# “Design and Analysis of an Ultrahigh-Speed Glitch-Free Fully Differential Charge Pump with Minimum Output Current Variation and Accurate Matching,”

*S. Cheng, H. Tong, J. Silva-Martinez and A. Karsilayan, IEEE Transactions on Circuits and Systems, part II, Vol. 53, pp. 843 - 847, Sept. 2006*

Response to reviewer #1:

Differential charge pump with excellent mismatch suppression.

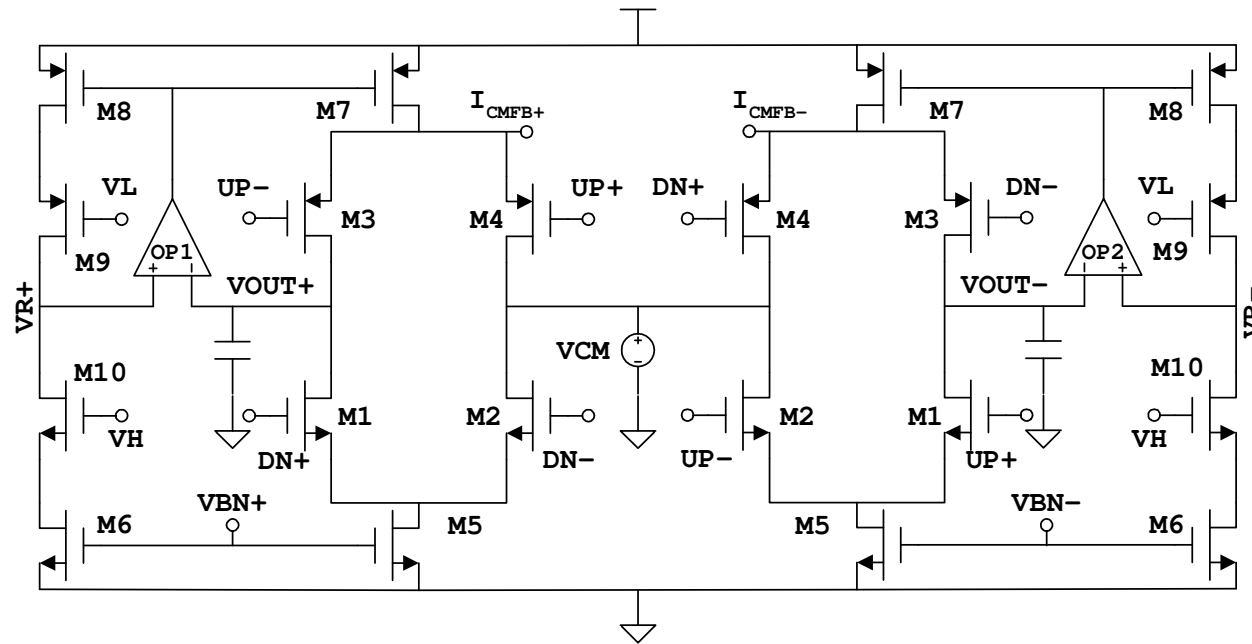
*(10) Control signals UP+, UP- look in different positions, with respect to control signals DN+ and DN-, in Figure 1 and Figure 2. This is probably due to the fact that, in Figure 2, signals UP+ and UP- are applied to PMOS devices. If so, probably, this should be stated in the paper, so as to prevent any risk of misunderstanding by the reader.*

Thanks for pointing out the potential confusion. We have added brief explanation in the passage **(WHAT DO YOU MEAN? BE MORE ESPECIFIC)** below 0 to indicate the fact that both UP and DN signal are active at high level.

Variation suppression circuit.

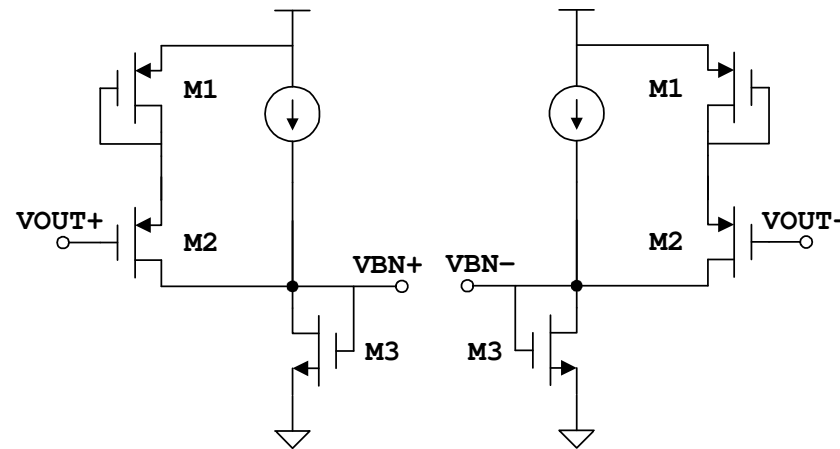
*(5) The operation of the circuit proposed to minimize output voltage variation as a function of the output voltage, is rather clear in principle. However, from a design point of view, it should be interesting to know some design criteria for this circuit (which is the criterion to determine the output voltage level which causes devices M1 and M2 in Figure 5 to conduct?).*

As a rule of thumb, M2 can be designed to conduct when the output transistor starts to enter triode region, i.e.,  $V_{OUT} = 2V_{dsat,NMOS}$ . DC sweep simulation can be done to achieve optimum compensation in actual design. This rough design criteria is added into the first paragraph after 0.

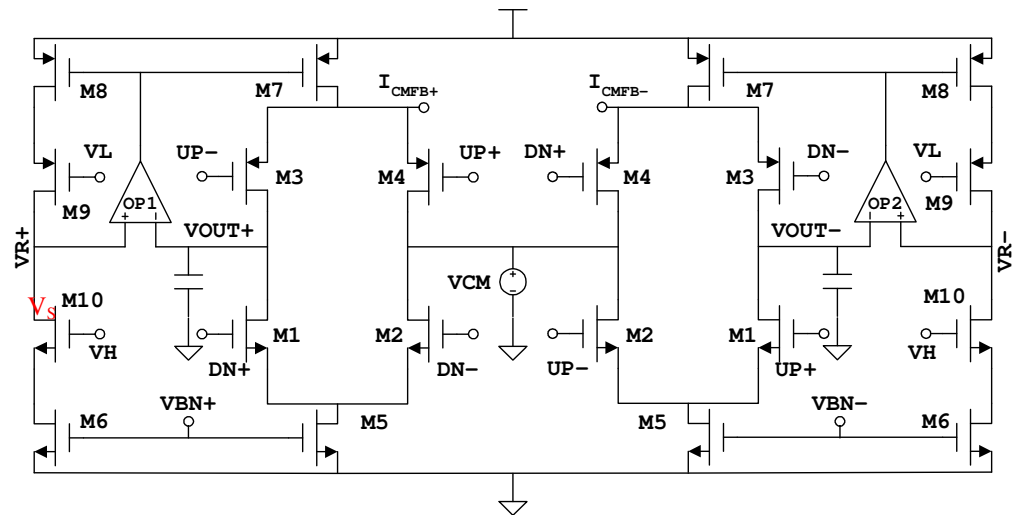
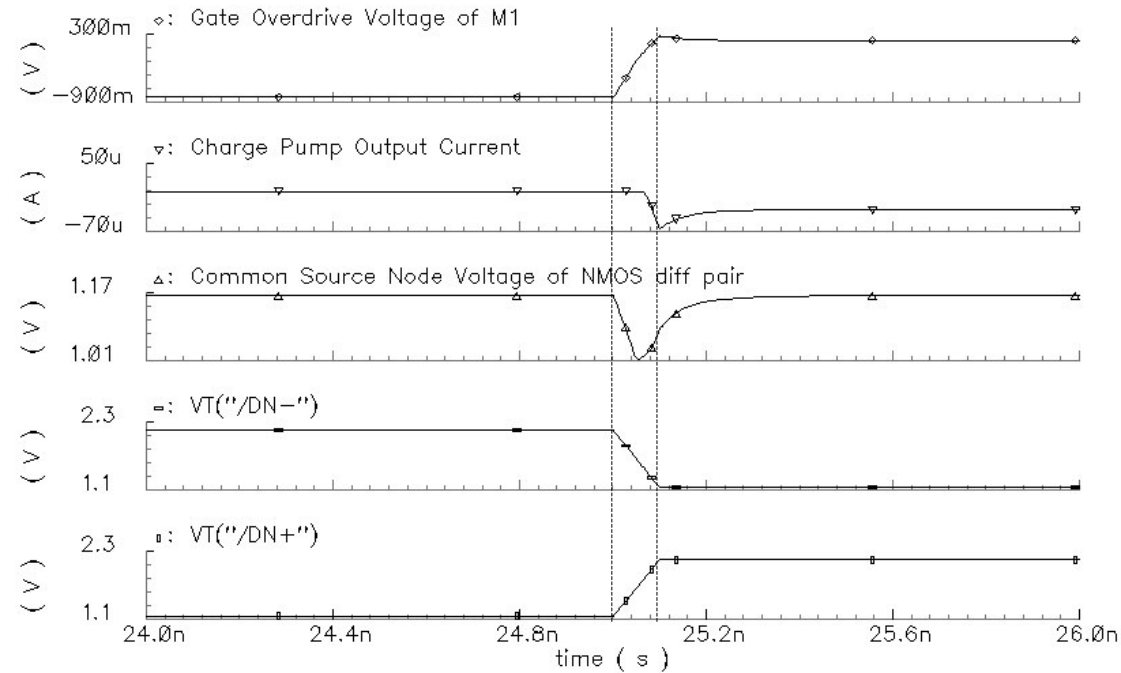
*(2) The issue of low-glitches seems to be not so clear. The paper states that the problem of glitches is due to the presence of an excessive gate-to-source voltage when the gate voltage of one of the devices in the differential pair, i.e., M1 and M2 (or M3 and M4) in Figure 2, rises very fast. According to the paper, referring to the NMOS differential pair, this is due to the fact that the common source of the differential pair is not able to follow the rising input signal. The technique to solve this problem consists in connecting*

*a (large) capacitor between the common-source node and ground. This ideally leads to a constant voltage at the common source node. We think that, if the low-speed glitch problem is due to the above cause, the presence of this capacitor should enhance rather than alleviate the problem. Indeed, the presence of this capacitor leads to a more constant voltage at the common-source node. This is also shown in the simulated waveforms in Figure 8 (in this Figure, it is also not clear why the large negative glitches are present in the common-source node without the glitch suppression capacitor). Therefore, we think that the item of low-speed glitches should be explained in a more clear way.*

0 is added to illustrate the generation mechanism of low-speed glitches. Detailed explanation is added into the first paragraph after the sub-title “Low-speed glitch”. The introduction of the large capacitance at the common source node is to intentionally slow down the speed so that the common source node voltage experiences little variation before and after the switching of the input signal. Thus, there is no overshoot of gate-to-source voltage and the glitches are eliminated.

Common source node voltage of NMOS diff. pair and output current with and without low-speed glitch suppression circuit.

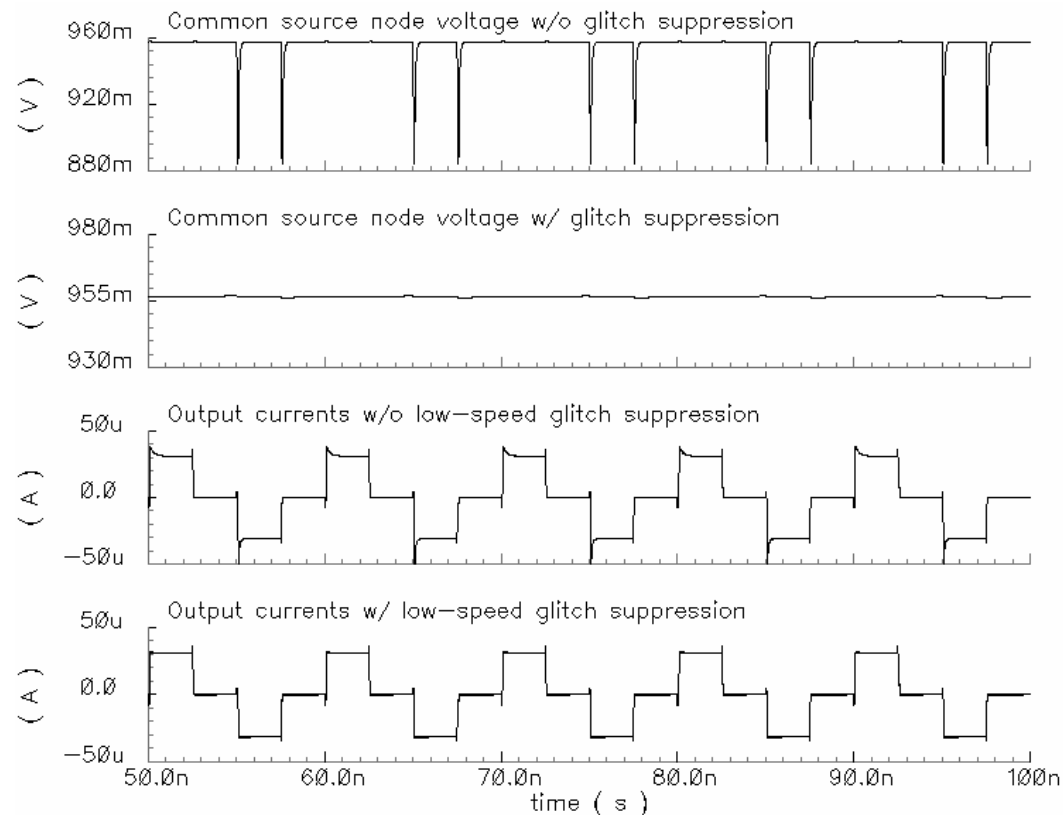
*(14) Figure 8. It should be better to specify that the first two waveforms are referred to the common source of the NMOS differential pair. Also, the corresponding waveforms of signals DN+ and DN- could be shown, to help the reader for better understanding.*

The caption of 0 was revised to indicate that the common source node voltage refers to the NMOS differential pair. For the waveforms of DN+ and DN-, please refer to 0 which is newly added.

Charge pump with high-speed glitch suppression circuit using dummy devices (enclosed in ellipses).

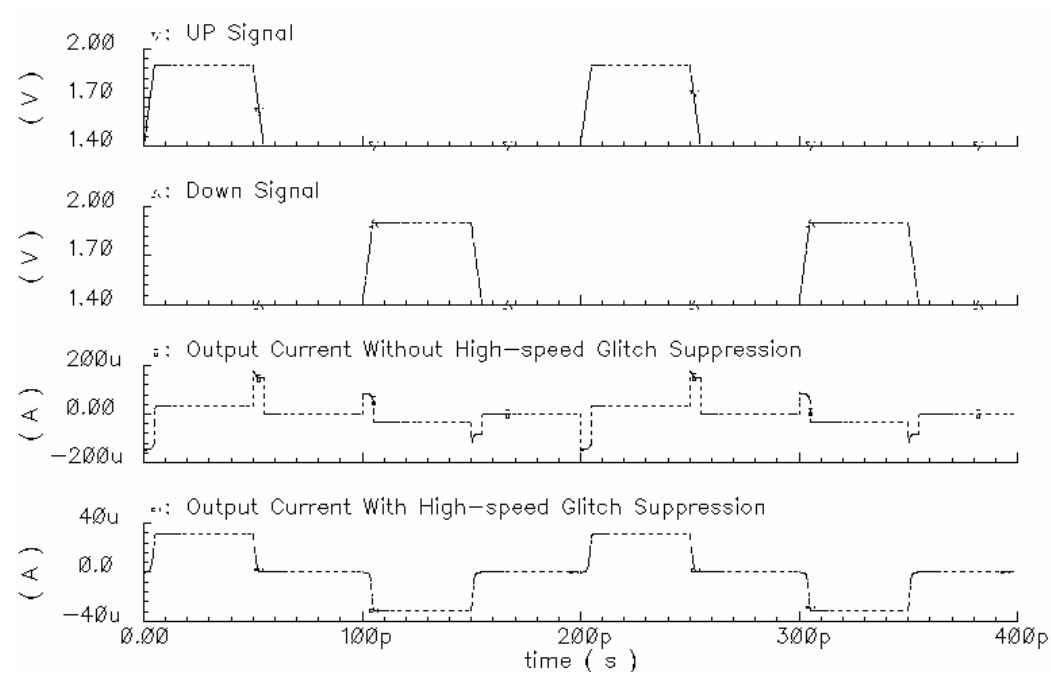
*(6) As for the technique to minimize on high-speed glitches, are the source terminals of the dummy devices (M1 and M3 in Figure 9) floating?*

Regarding the high-speed glitch suppression techniques, the source of the dummy transistors is floating because we don't want them to conduct any current to affect the output current value. In this case, there is no difference between the source and drain terminals because they have the same voltage. This is mentioned in the first paragraph after figure 11.
